NUMBER 72

SUBJECT: Rudder Pedal and Floorboard Attachment Lugs

MODELS AFFECTED: J3 and J5 Series

FLOORBOARD FITTING REPAIR

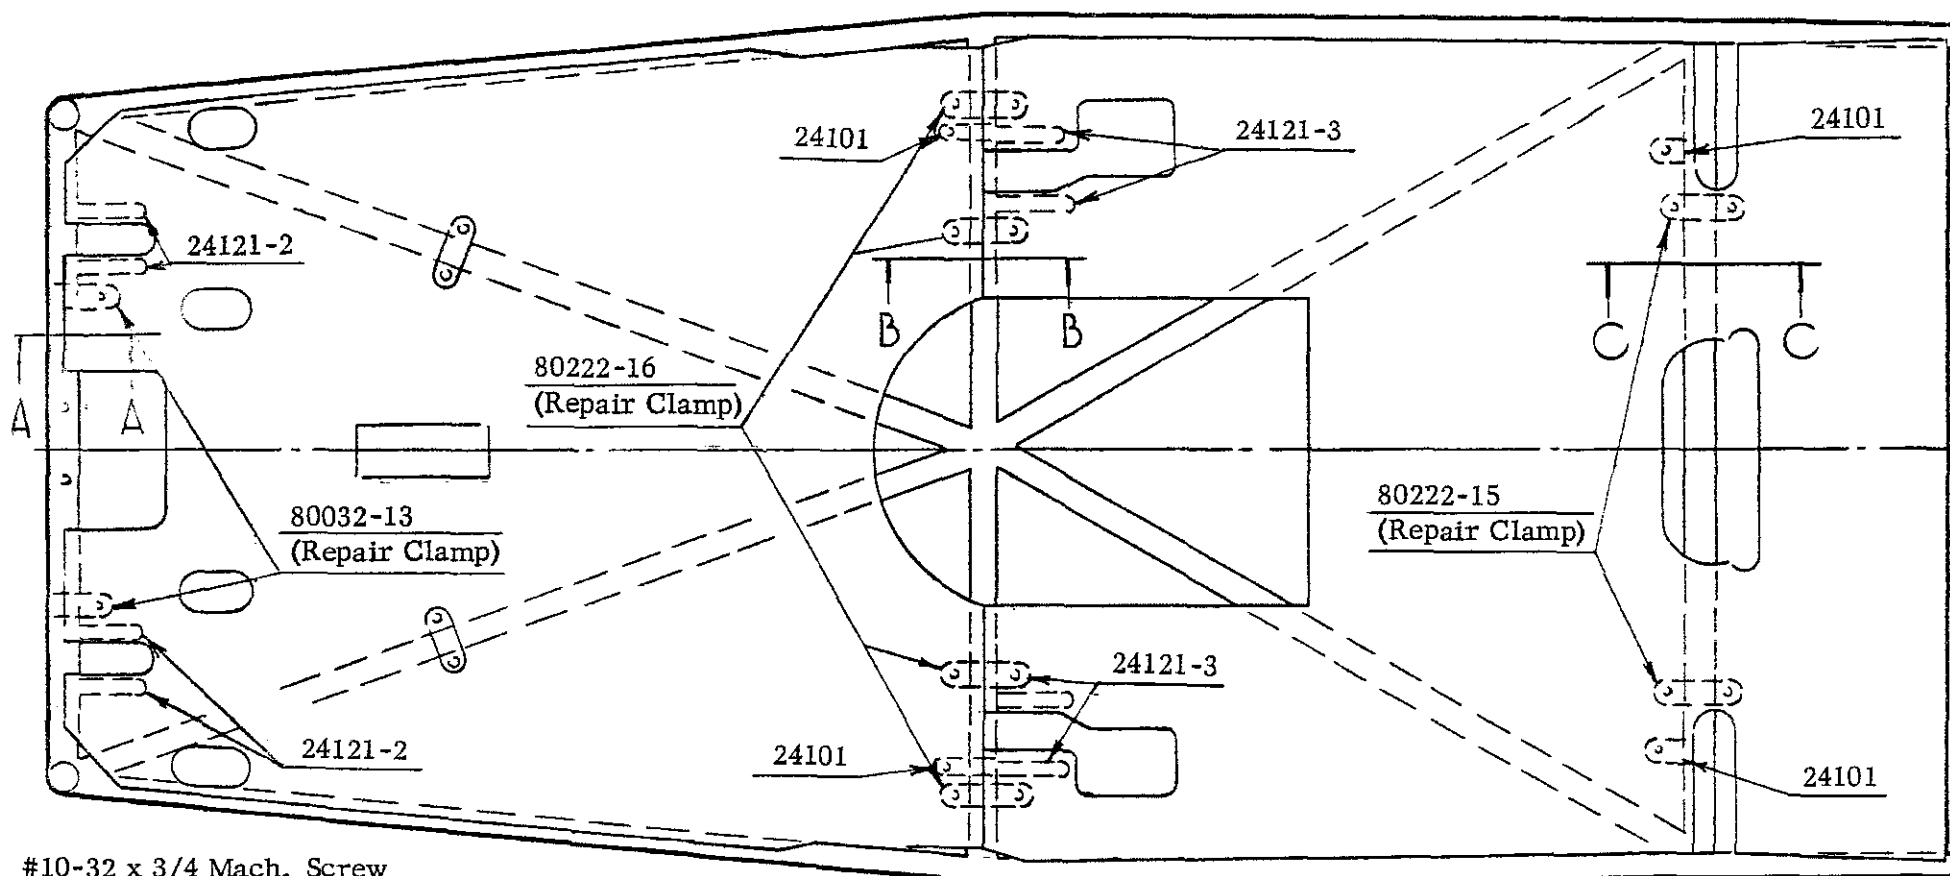
A number of reports have recently been received regarding failure of the floorboard and rudder pedal lug attachment to the tubular structure. This is apparently due to continued flexing of these parts during operation. As it may be possible to foul the controls as a result of such failures, we recommend that an immediate check be made to determine whether or not these fittings are intact on your airplane.

In the event that such failures are discovered, a temporary repair may be effected by attaching the floorboard with a clamp fastened about the tubular structure immediately adjacent to the failed part. (See attached sketches.) SAE No. 1025 steel strip .045" thick by 3/4" wide is recommended for such clamps. The original fittings should then be re-welded or replaced when convenient; in which case the repair clamps may be reinstalled for additional strength.

#10-32 x 3/4 Mach. Screw

80122-11

Plain Nut 14 Req'd.
